# **Appendix C: Public Comments**

## **For the Report of the Ad Hoc Advisory Committee on South Flow Arrivals**

**Received after 4/27/18**

Figure 2.

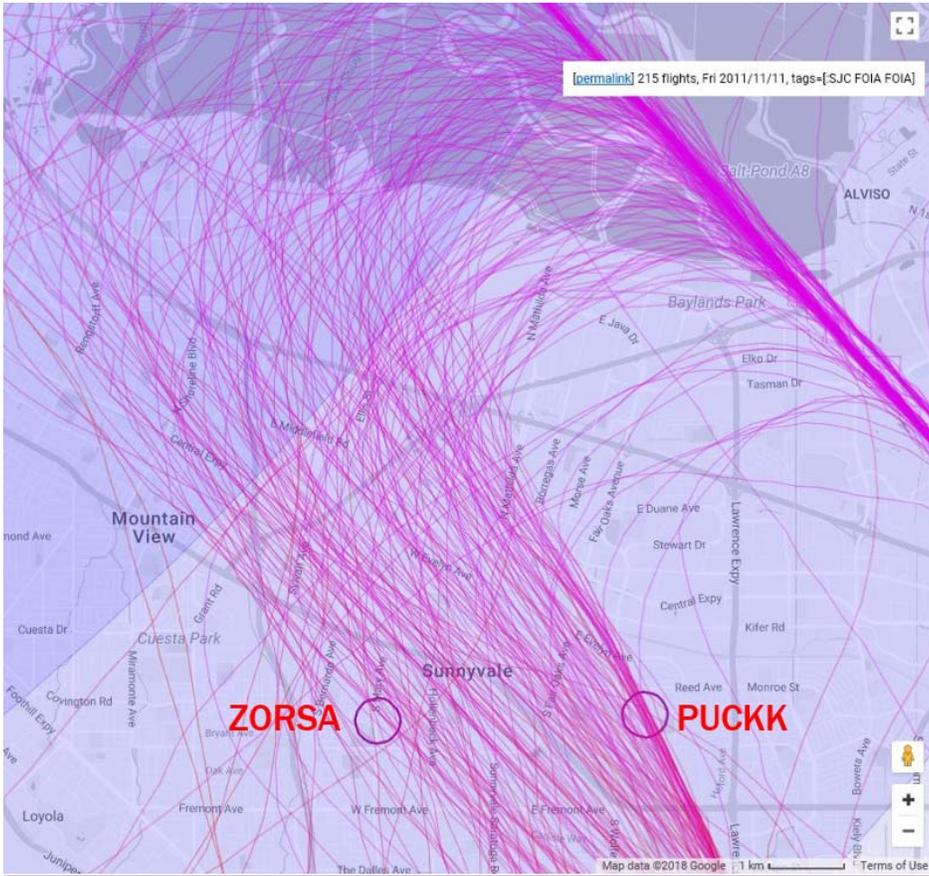
**Commented [RH10]:** HIGH: The FAA has, at times, described the 'rails' differently than the Committee has, so it's important to be clear. If it's inappropriate to embed a picture, consider stating, "please see Appendix, *Community Recommendations for the Ad Hoc Advisory Committee - 4/24/18, Figure 2*"

Figure XX

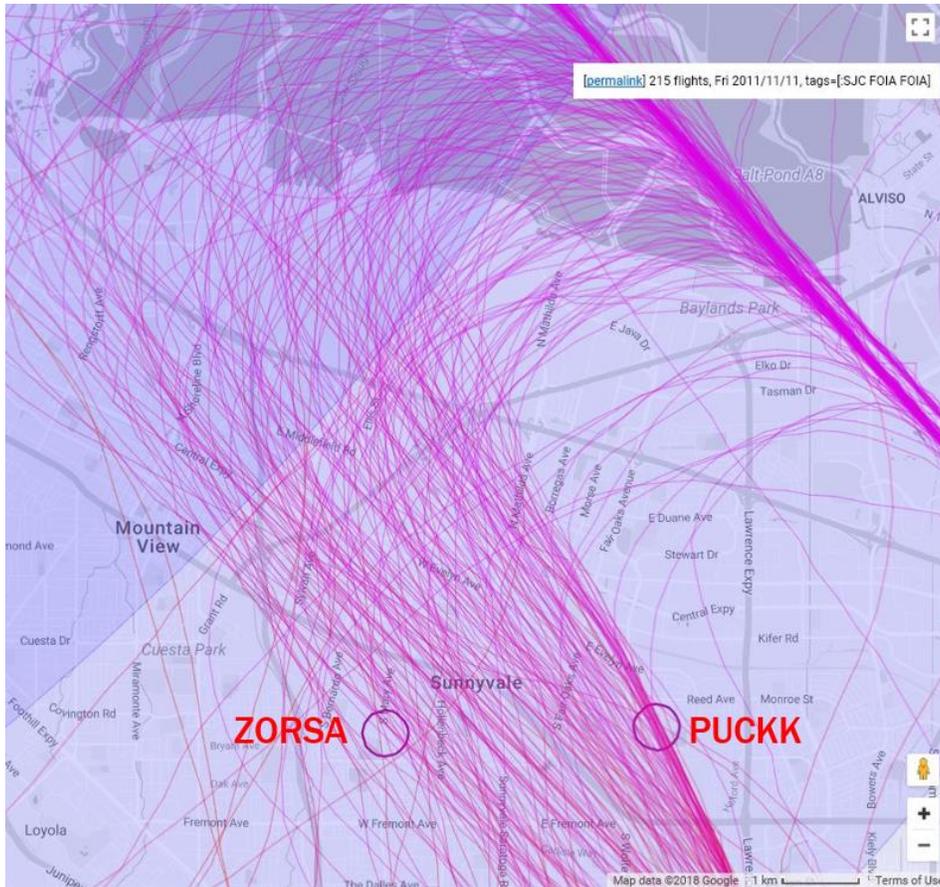
**Commented [JT2]:** Would be helpful to have a picture of the historical dispersion in this section, so the historical dispersion level is clear to all parties.

Figure 1. Dispersion prior to 2012. (1/11/11)

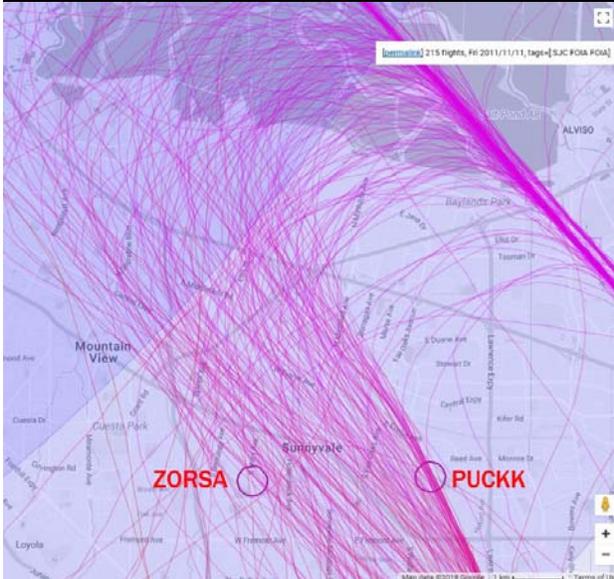
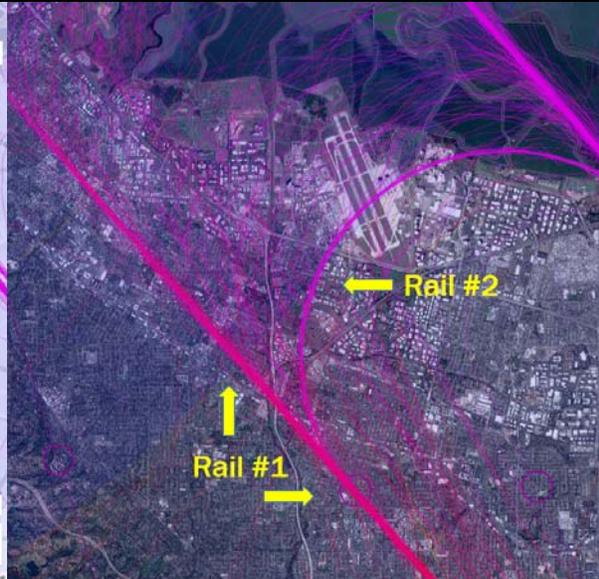
Prior to the implementation of NextGen, aircraft were dispersed over a broader area of air space thereby limiting concentrated negative effects on residents and neighborhoods. *See the map in Figure 1 below showing the dispersion of aircraft between the ZORSA and PUCK waypoints prior to 2012.* A dramatic increase in noise complaints resulted from the implementation of NextGen. NextGen, a program which switched a radar-based approach to a GPS approach, has resulted in the use of Required Navigation Performance (RNP) and Optimal Profile Descent (OPD). These tools and procedures create a concentration of flight paths *or “rails”* over specific neighborhoods and homes, which now bear the brunt of ground effect noise. *See the map in Figure 2 below showing the two rails that developed with the FAA’s move to NextGen.*

**See Attachments to this email for Figure 1. Dispersion prior to 2012. (1/11/11) and Figure 2. Two rails after Nextgen (3/10/16)**

Figure 1. Dispersion prior to 2012. (11/11/2011)  
ZORSA is ~2nm (2.3 miles) west of PUCKK

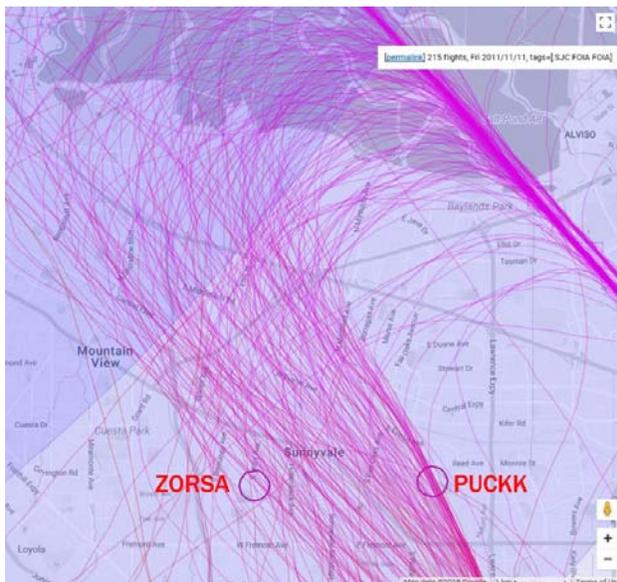
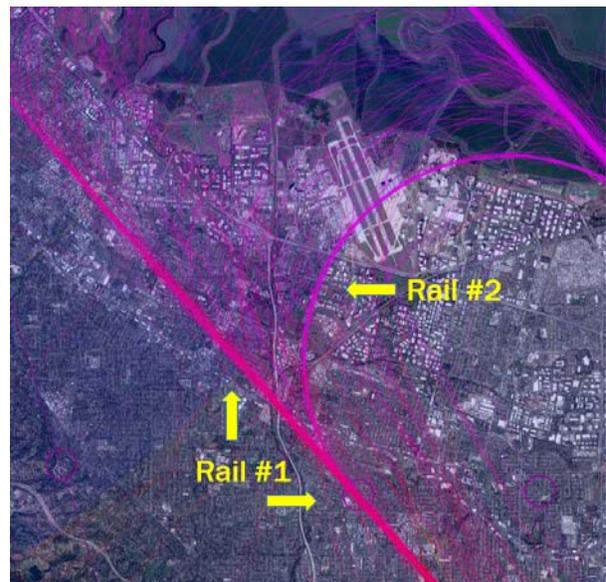
- **Add a diagram that shows the dispersion we previously had and seek to return to.**
  - **Add:** Figure 1. Suggested location: after first paragraph, page 8. The dispersion of November 11, 2011 describes historical patterns that existed for many years. A picture is worth 1000 words, and it is important for this picture to be included in the report so that all parties are clear on what was lost and what we would ideally return to. It is too easy to be confused about what is sought otherwise. This is also too important to be left to an appendix.

- **Add:** "*see figure 1*". Suggested location: end of first sentence, page 8.
- **Clearly acknowledge the two rails. The report only acknowledges one!**

- **Add** a diagram (figure 2) showing the two rails. Suggested location: after first paragraph, page 8. The current report does not reference the other rail and at the last meeting Mr. diBernardo seemed not to acknowledge it either. Proof that the ambiguity is too important to be left to the appendix!

*Directionally, the Committee recommends that the FAA drive toward: 1) alternatives to routing airplanes over fixed rails; 2) reversion to ground noise patterns prior to 2012, in the same geographic proportions (figure 1).*

Image 1 - SJC Historical tracks prior to 2012 over Sunnyvale

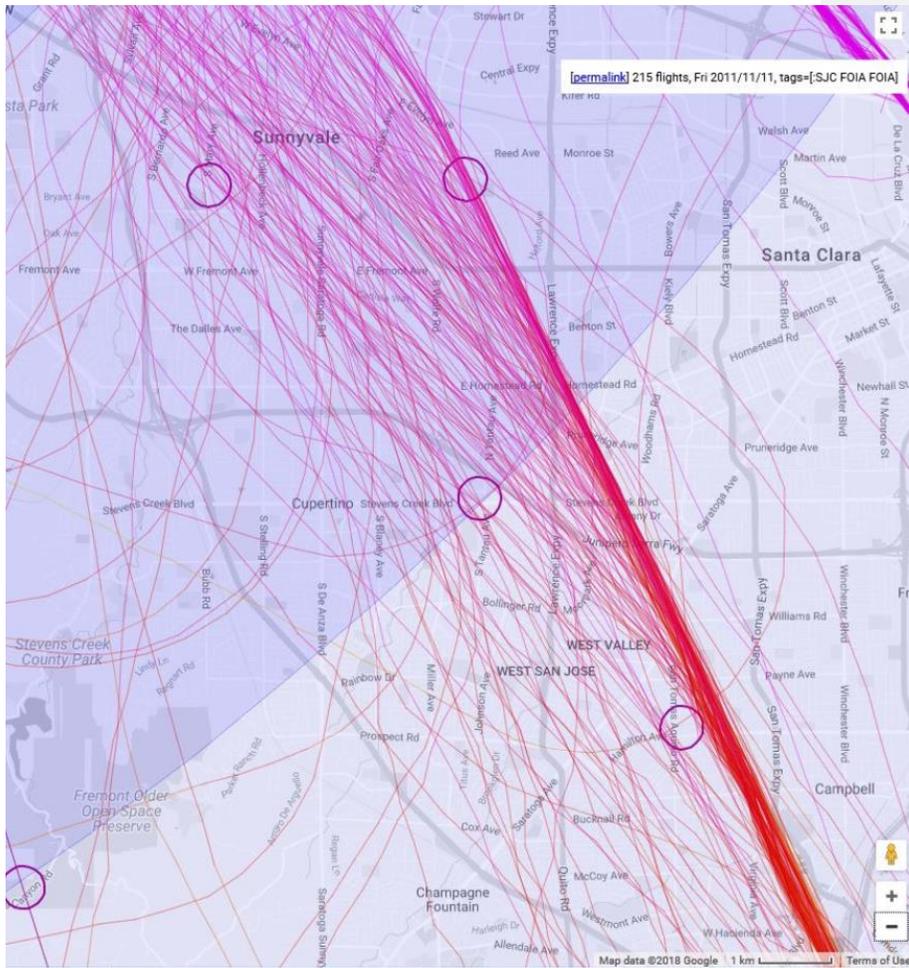
A possible success criteria: Sunnyvale to see the level of dispersion that existed prior to 2012. Flights were dispersed evenly over an approximately 2.5 mile wide corridor between waypoints ZORSA and PUCKK (See image 1 for sample desired dispersion – SJC Historical tracks prior to 2012).
